International Aero Engines SERVICE BULLETIN

AIR - COOLING - IGNITION COOLING LEADS -
INTRODUCTION OF NEW IGNITION EXCITER
COOLING TUBES

EC94VR046

V2500-ENG-75-0043

Figure 12

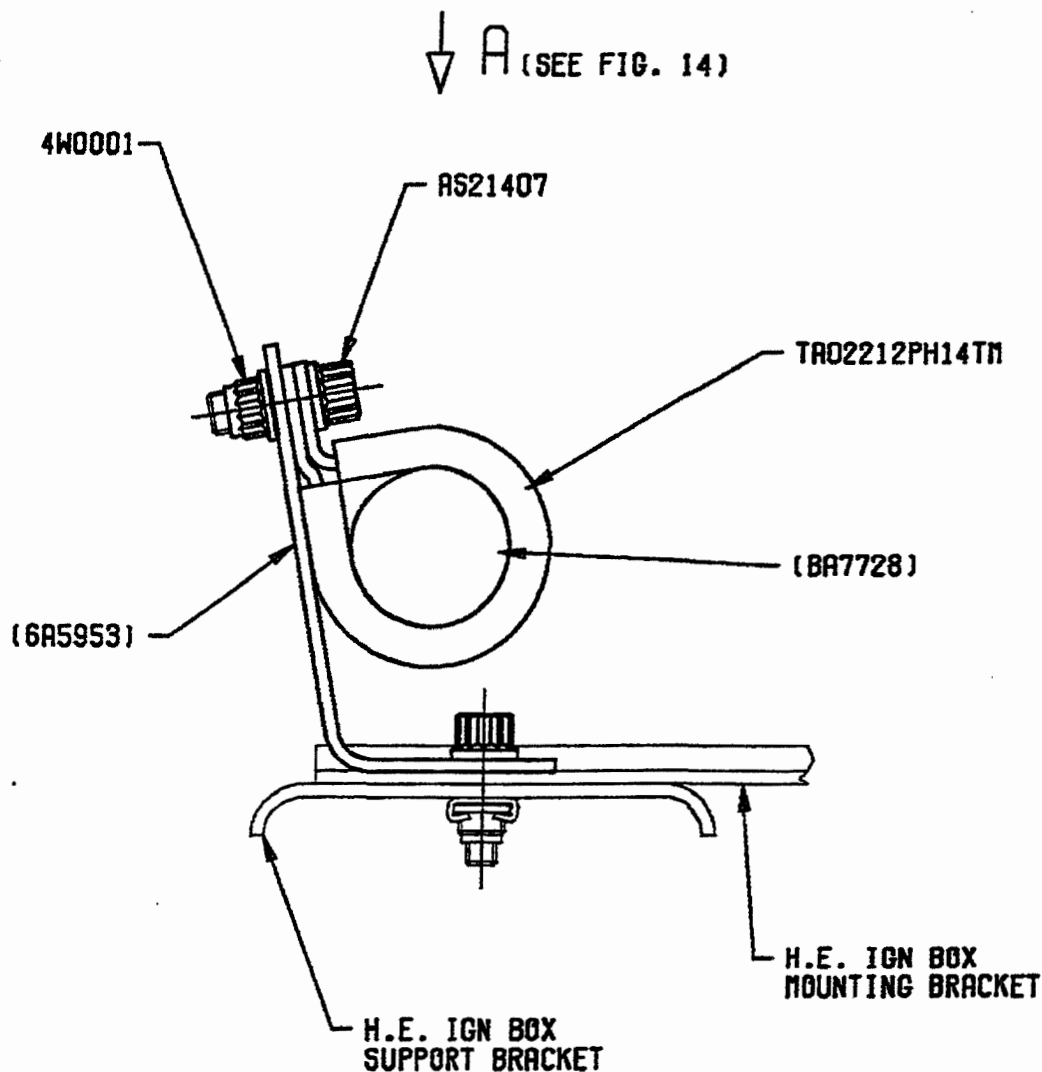
A new bracket, 6A5953 is added to support flexi-tube at CP8061.

Clipping point 8061 (See Figure 14) looking
forwards - Added

- (12) Clip the BA7728 ignition exciter cooling air tube to the 6A5953 bracket at clipping point 8061 using the AS21407 bolt, TA02212PH14TM clip and 4W0001 nut. Torque the bolt to 36 to 45 lbfin (4 to 5 Nm). Refer to Figures 3 and 12.

Figure 13

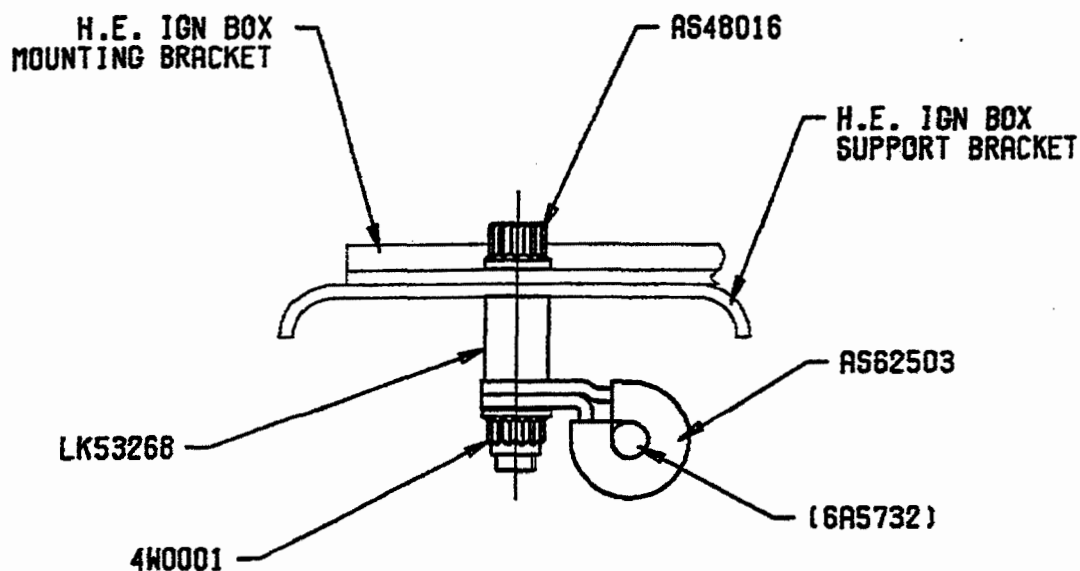
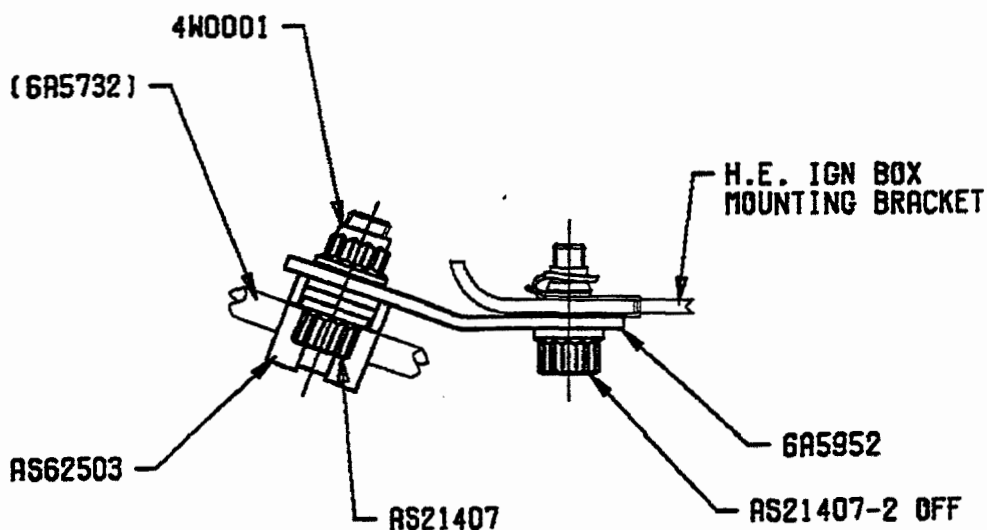
A new bracket, 6A5952 is added to support loom E at CP8063.

CLIPPING POINT 8062 - ADDED
LOOKING FORWARDS
(SEE FIG. 14)

CLIPPING POINT 8063 - ADDED
(SEE FIG. 14)

- (7) Clip the loom E harness 6A5732 to the ignition exciter box support bracket at clipping point 8062 using the AS48016 bolt, LK53268 spacer, AS62503 clip and 4W0001 nut. Torque the bolt to 36 to 45 lbfin (4 to 5 Nm). Refer to Figures 3, 13 and 14.

- (8) Clip the loom E harness 6A5732 to the 6A5952 bracket at clipping point 8063 using the AS21047 bolt, AS62503 clip and the 4W0001 nut that was previously used at clipping point 7046. Torque the bolt to 36 to 45 lbfin (4 to 5 Nm). Refer to Figures 3, 4, 13 and 14.

Figure 14

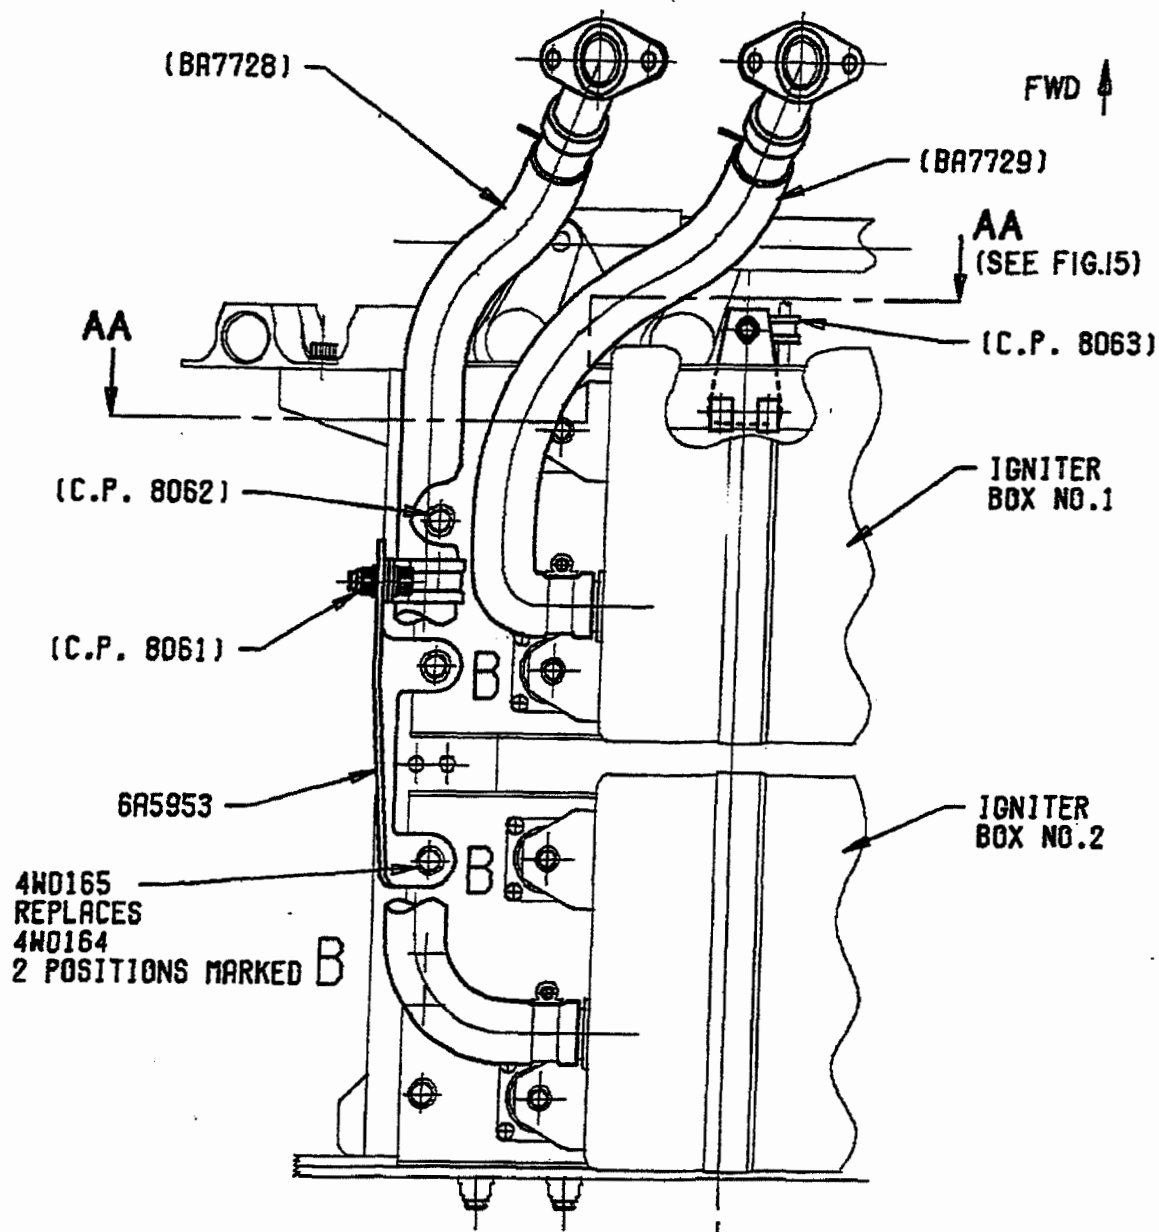
View on arrow A (See Figure 12) showing clipping points at igniter boxes

- (2) Install the new 6A5952 bracket on to the ignition exciter box mounting bracket using the AS21047 bolts. Refer to Figures 13 and 14.
- (3) Connect the 6A6149 P2.5 air tube to the P2.5 sensor. Connect the 6A6151 P2.5 air tube to the 6A6149 tube and also to the interface tube on the RH bifurcation panel. Torque the tube coupling nuts to 159 to 177 lbfin (18 to 20 Nm). Wire lock the nuts using CoMat 02-126 lockwire. Refer to Figure 3.

- (10) Install the new 6A5953 bracket at position 'B' on the No.1 and No.2 ignition exciter mounting brackets using two 4W0165 bolts. Torque the bolts to 85 to 105 lbfin (10 to 12 Nm). Refer to Figure 14.

Figure 15

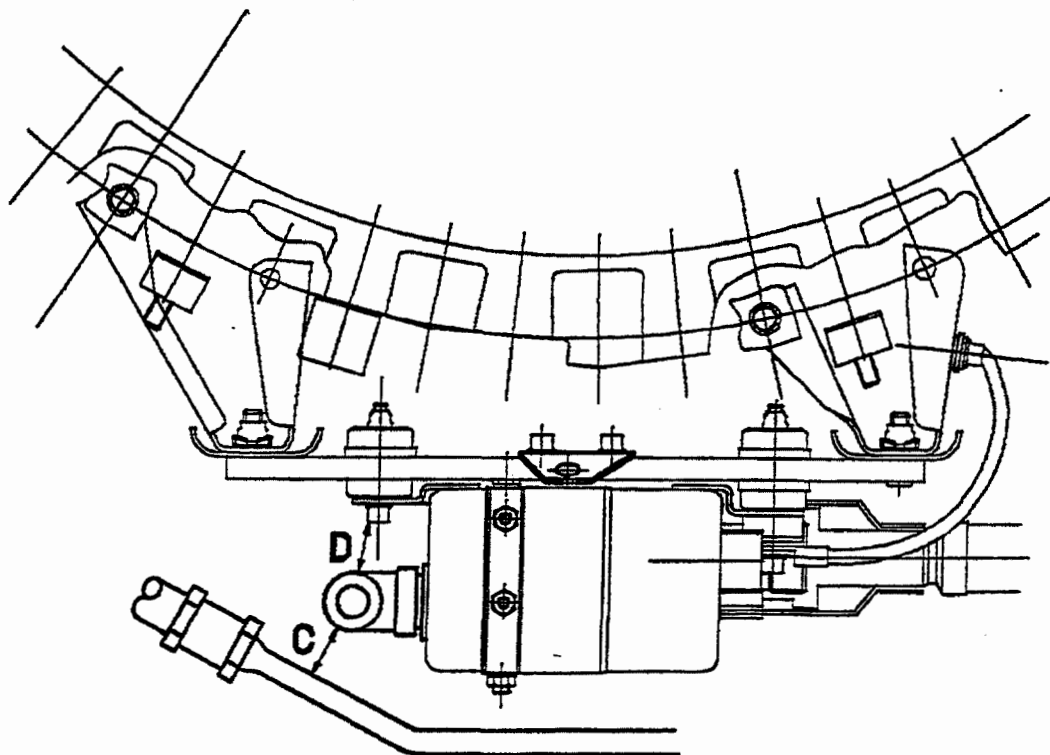
**PART VIEW ON SECTION AA (SEE FIG.14)
SHOWING POSITION OF IGNITER COOLING AIR HOSE
AFTER ALTERATION**

**NOTE: COOLING HOSE TO THE FORWARD IGNITOR BOX IS TO BE ADJUSTED AT THE
COOLING BOX INTERFACE SUCH THAT WHEN FITTED, EQUAL CLEARANCE IS
ACHIEVED BETWEEN THE IGNITOR BOX SECURING BOLT AND THE BSBVA
SERVO SUPPLY TUBE.**

- (20) Clip the 6A6148 servo fuel tube to the 6A6147 servo fuel tube at clipping point 8060 using the AS21408 bolt, AS62405 clip and 4W0001 nut. Torque the bolt to 36 to 45 lbf·in (4 to 5 Nm). Refer to Figures 3 and 11.
- (21) Visually check the clearance, C, between the BA7729 ignition exciter cooling air tube and the master BSBVA servo tubes, 6A6147 and 6A6148, and also the clearance, D, between the BA7729 tube and the igniter box securing bolt. If these clearances are visually unequal then loosen the clamp at the igniter box end of the BA7729 tube and rotate the tube on the igniter box fitting until the clearances appear equal. Tighten the clamp screw by hand. Refer to Figure 15.
